OCONEE NUCLEAR STATION, UNITS 1 & 2

AMENDMENTS TO FACILITY OPERATING LICENSES

Amendment No. 1
License Nos. DPR-38 and
DPR-47

SAFETY EVALUATION BY THE DIRECTORATE OF LICENSING
SUPPORTING AMENDMENT NOS. 1 TO LICENSE NOS. DPR-38 AND DPR-47
(CHANGE NOS. 11 AND 6 TO APPENDIX A OF TECHNICAL SPECIFICATIONS)

CONTROL ROD GROUP WITHDRAWAL LIMITS FOR 4 PUMP OPERATION

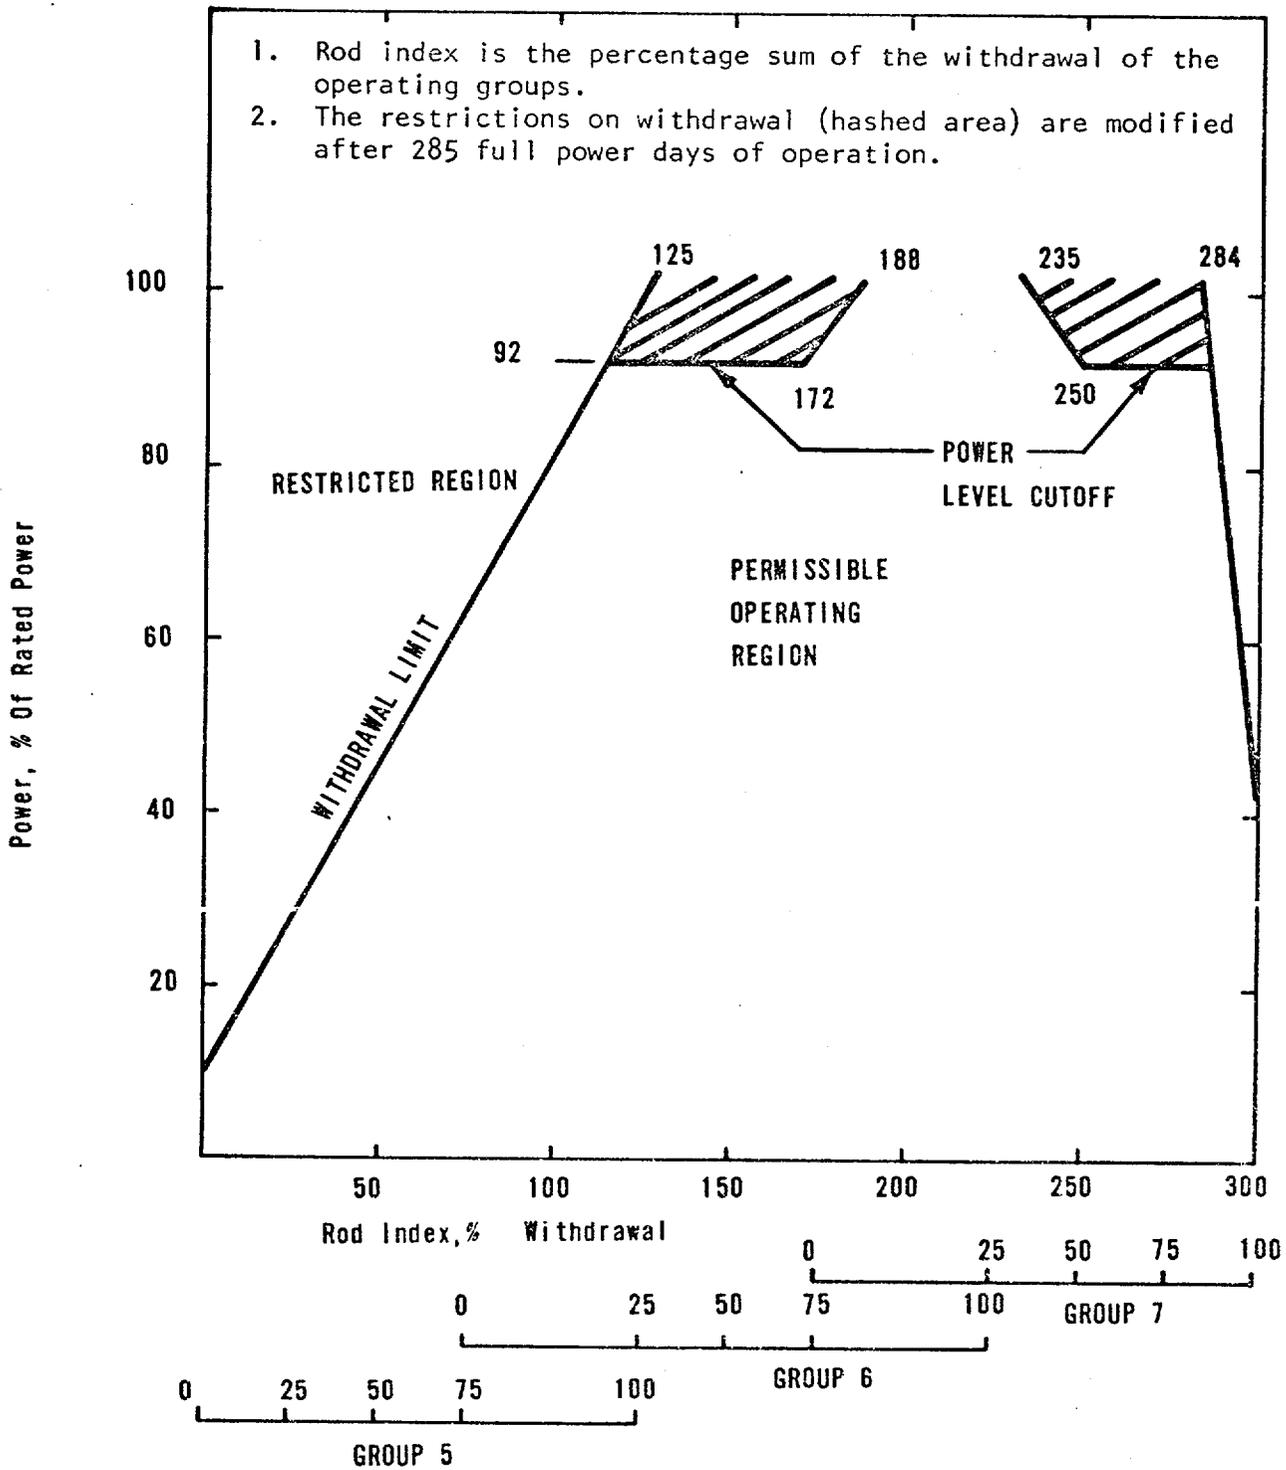
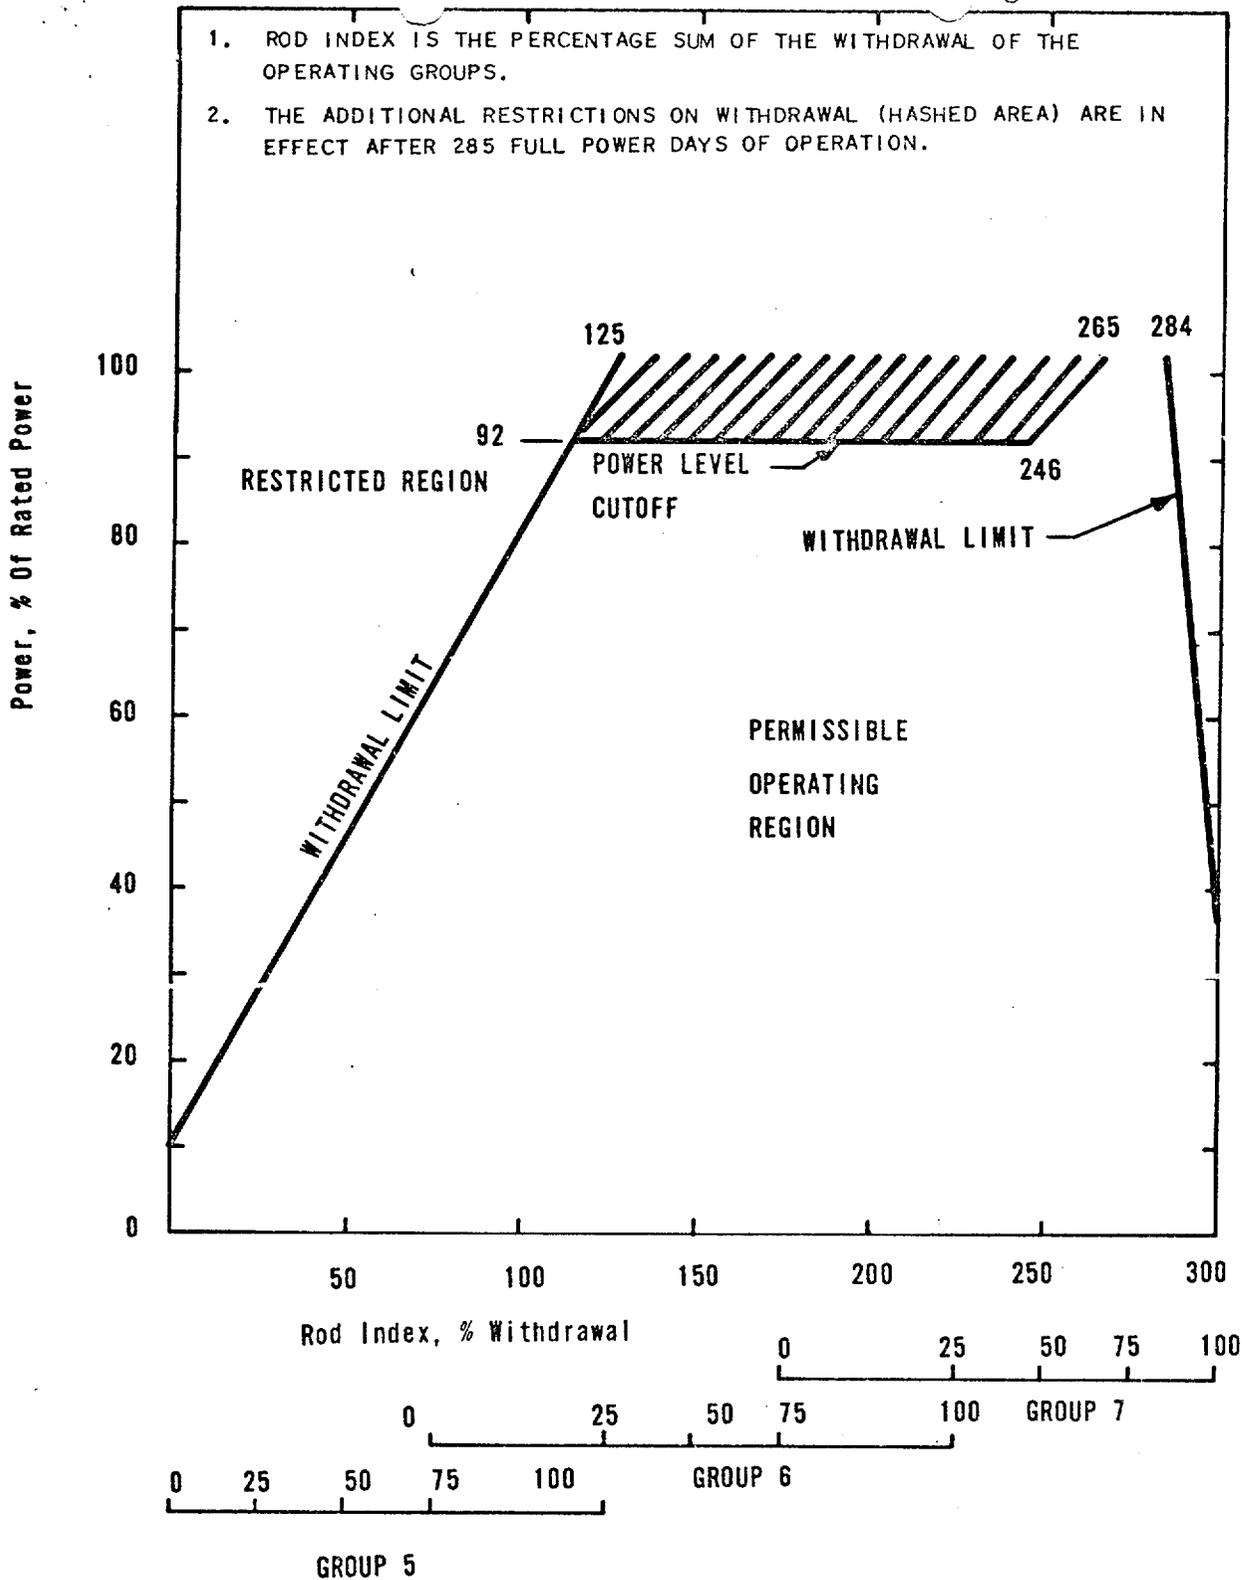
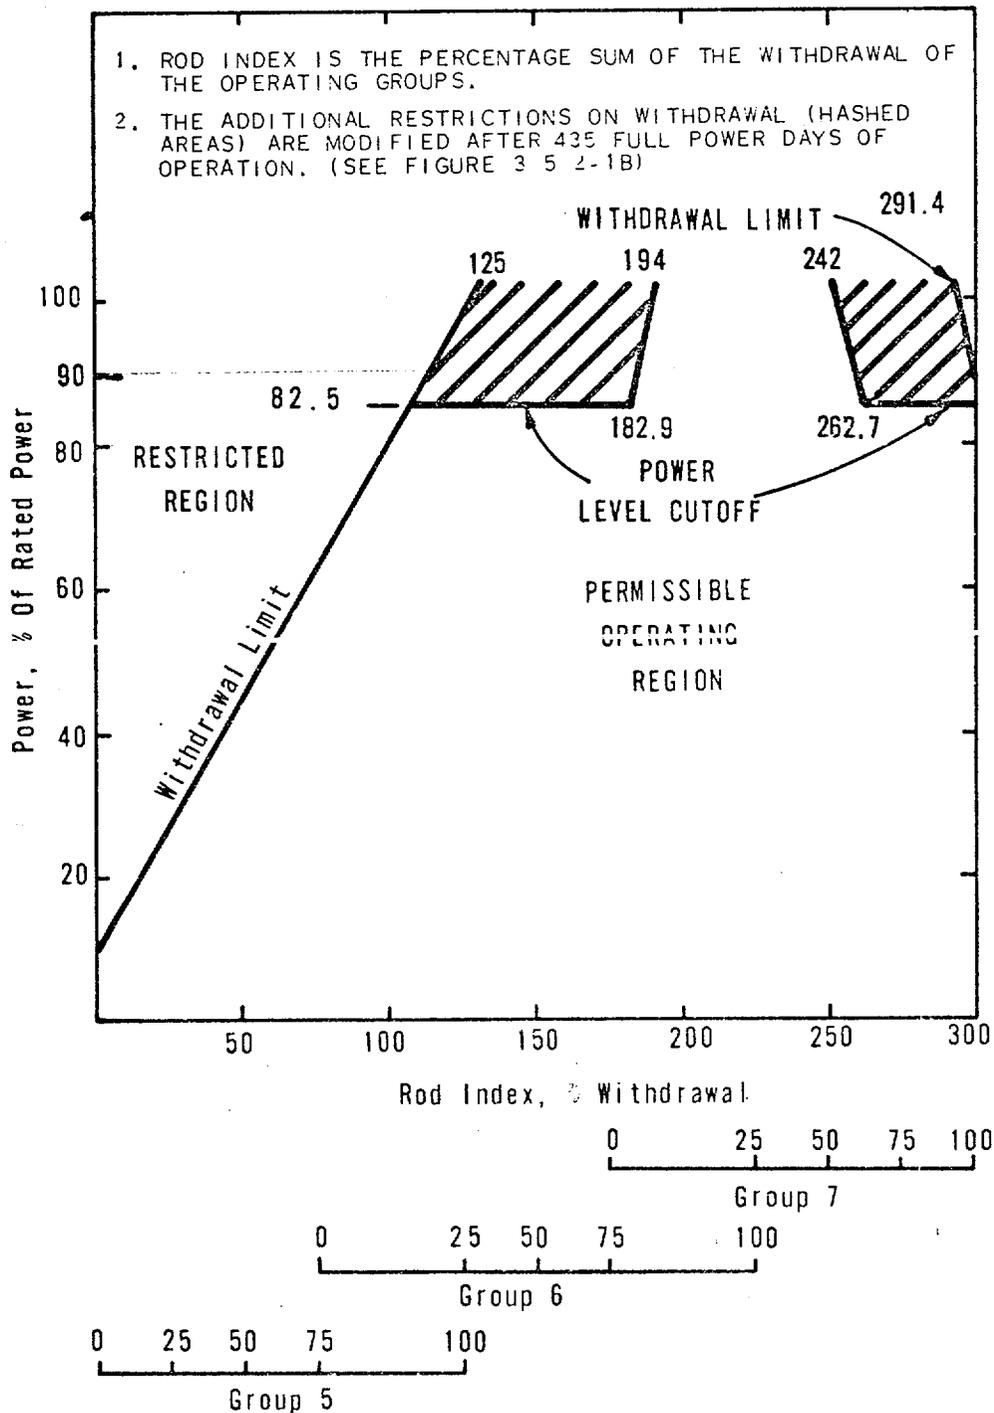
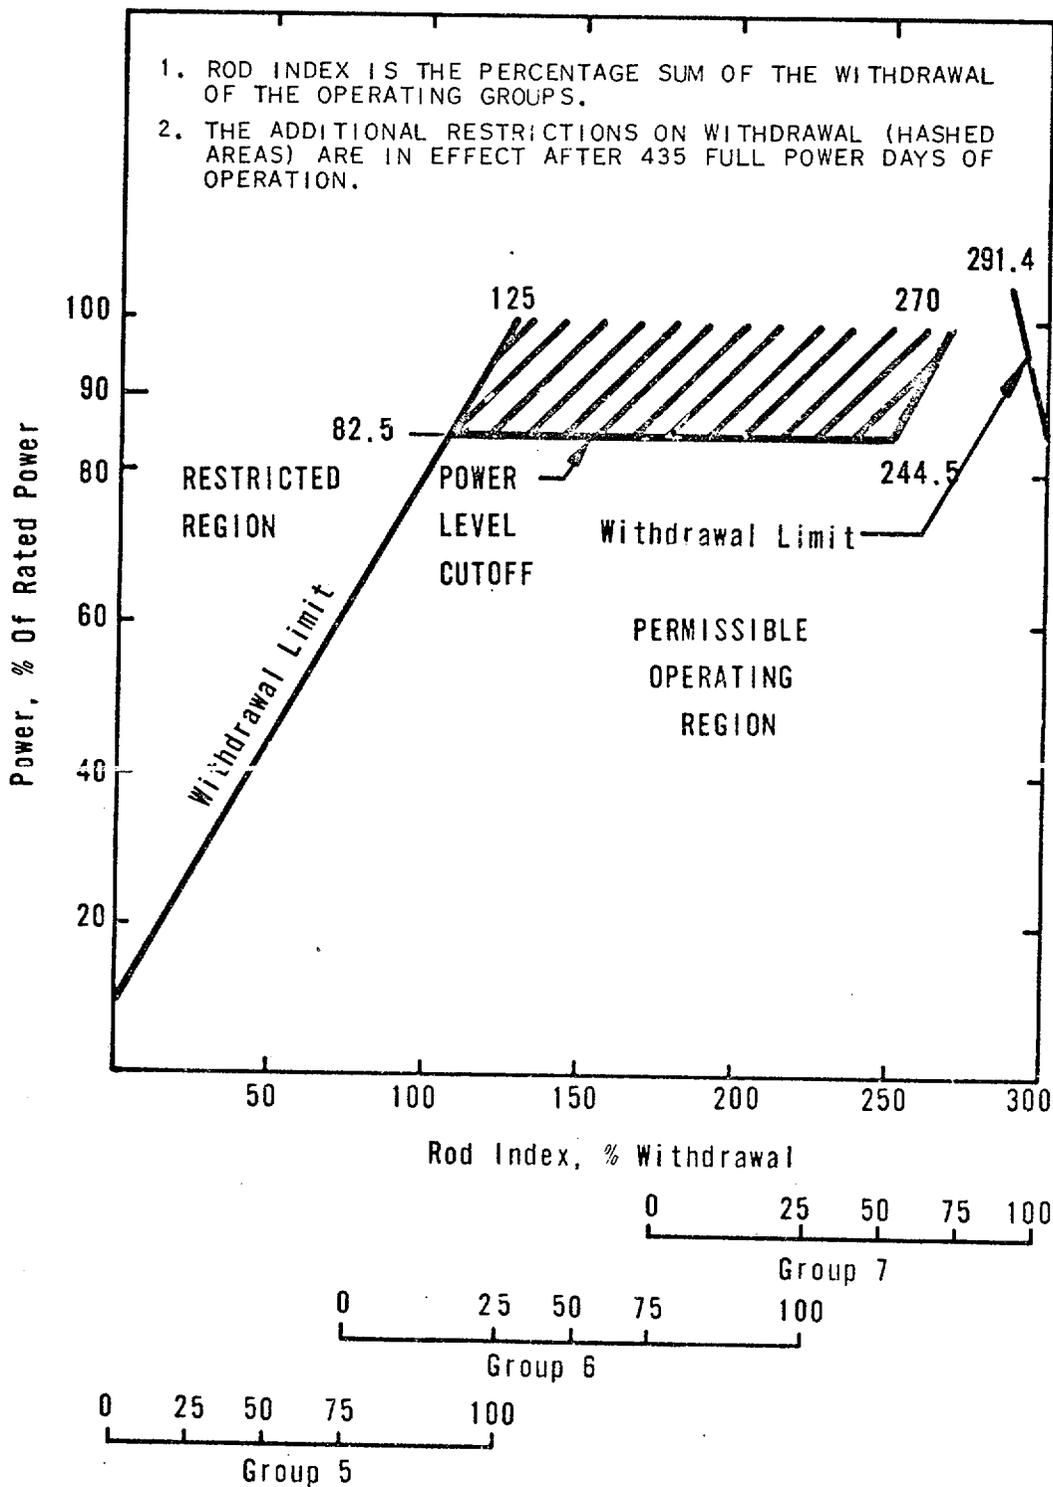
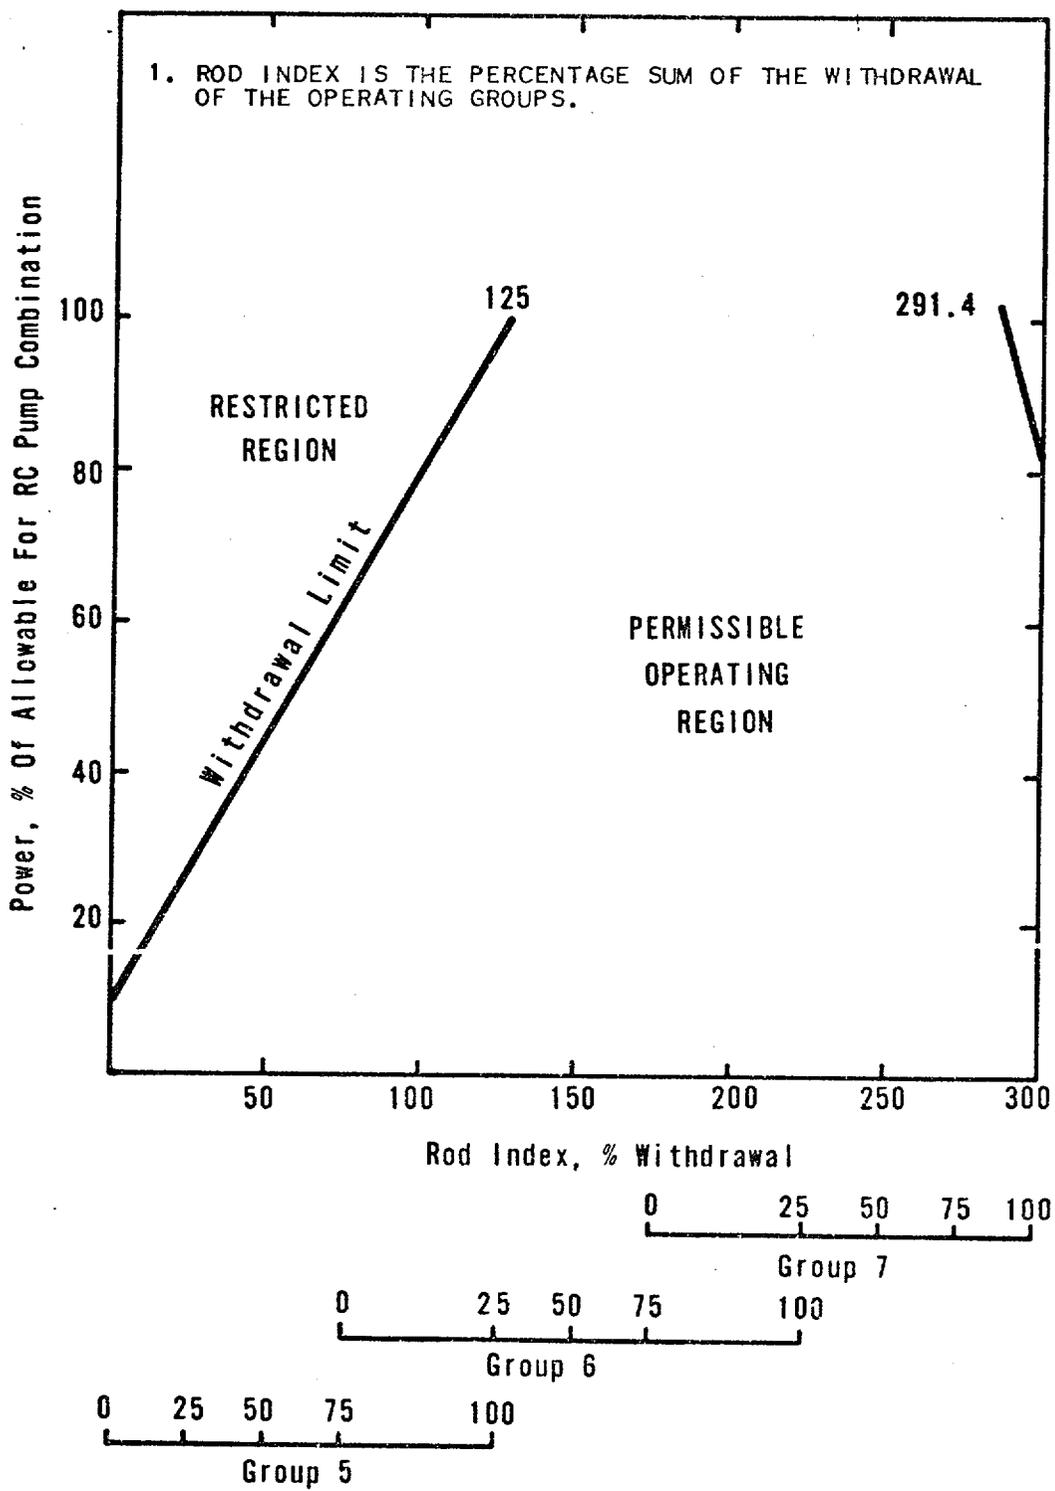
The control rod withdrawal limits given in Technical Specification 3.5.2.5c are specified in separate figures for Oconee Unit 1 and Oconee Unit 2. The control rod withdrawal limits for Oconee Unit 2 are only slightly changed from those in the current Technical Specifications; the changes primarily reflect the reduction in the quadrant power tilt limit from 5 to 4 percent. Oconee Unit 1 control rod withdrawal limits are changed considerably. The changes in the limits are made possible by items (1) through (3) listed above as "Bases for Changes in the Technical Specifications", and primarily by item (2), the higher fuel density in the Oconee Unit 1 core. Evaluation of the new rod withdrawal limits, in combination with other changes discussed in the safety evaluation, against previously approved core power peaking factors shows that the factors are not increased. Previously approved design margins of safety are maintained.

An addition has been made to the control rod withdrawal limit Technical Specification which requires that, if control rod withdrawal limits are reached, corrective action to achieve acceptable control rod positions must be taken immediately. Acceptable control rod positions must be attained within two hours. The intent of this addition to the Technical Specification is not to provide a broader operational control rod band, but to provide a small margin in time to achieve the proper boration/deboration of the coolant.

- (1) If four reactor coolant pumps are in operation, the allowable thermal power shall be reduced by 2 percent of full power for each 1 percent tilt in excess of 4 percent below the power level cutoff (see Figures 3.5.2-1A1, 3.5.2-1A2, 2.5.2-1B1 and 3.5.2-1B2).
